**HISTORIC ARCHITECTURAL REVIEW BOARD  
CITY OF ALLENTOWN, PENNSYLVANIA  
July 6, 2020**

**FINAL REVIEW**

**Address:** 114 N. West Street –

<b>Property Owner:</b>	Ernesto Colon	<b>Owner Address:</b>	114 N West St, Allentown, PA 18102
<b>Applicant:</b>		<b>Applicant's Address:</b>	Same
<b>Historic District:</b>	West Park	<b>Case #</b>	HDC-2020-00006
<b>HARB Meeting date:</b>	July 6, 2020 (Agenda Item #1)

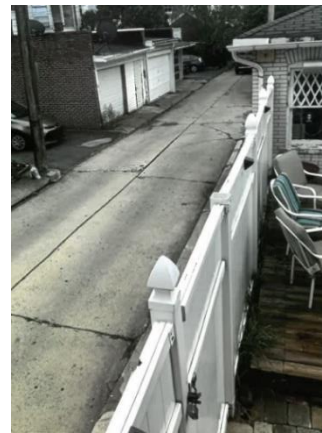
**Evaluation, effect on historic district, recommendations:** The Design Guidelines allows decks and patios to be constructed at secondary facades. Wood is an appropriate material. This gazebo is to be constructed of cedar and have cedar framing and braces. The roof is to be a panelized standing seam metal which is an appropriate material. The height of the roof is to be 10'. Assuming the existing fence is about 6' tall, about 4' of the gazebo will be visible above the fence if the gazebo is located close to the fence. If possible, the gazebo should be constructed on the other side of the rear yard so that it is less visible from the street.

**Discussion:** The applicant clarified the dimensions of the proposed gazebo and the size of the yard. The yard is 15' wide. The distance between the house and the garage is 20'. The proposed gazebo is 12' x 14'. The space between the gazebo and the neighbor's fence would be only 3' if the gazebo placed against the fence at the sidewalk. Likewise there would be only 3' between the gazebo and the house and the gazebo and the garage if it were centered in the yard. HARB members agreed that gazebo was too large for the yard. There was also concern about water being directed to the neighboring yard, but the applicant said he would be installing a gutter. The HARB also pointed out that zoning review would be needed and that it might not meet zoning regulations. The applicant said he was aware of this. He then confessed that he already purchased the gazebo from Home Depot (or Lowes?). Ms. Olsen said these stores have good return policies.

**Motion:** The HARB upon motion by Mr. Fillman and seconded by Ms. Roberts adopted the proposal that City Council **DENY** a Certificate of Appropriateness for the proposed work described herein:

1. The proposal to install a gazebo in the rear yard at 114 N West Street was represented by Ernesto Colon.
2. The proposed gazebo is 12' (W)x 14' (D) x 10' (H) and would be made of cedar posts and framing. The roof is a standing seam panelized metal roof.
3. The gazebo is proposed to be located close to the garage and almost abutted to the fence along the side street.
4. The size of the yard is 15' x 20'
5. The structure is inappropriately large and would cover approximately the entire yard.
6. The gazebo was purchased without approvals.

**HARB Action:** The proposal to DENY a COA for the reasons outlined in the discussions above, and was unanimously approved. (6-0; motion carried: Sell, Brobst, Fillman, Huber, Olson, Roberts).
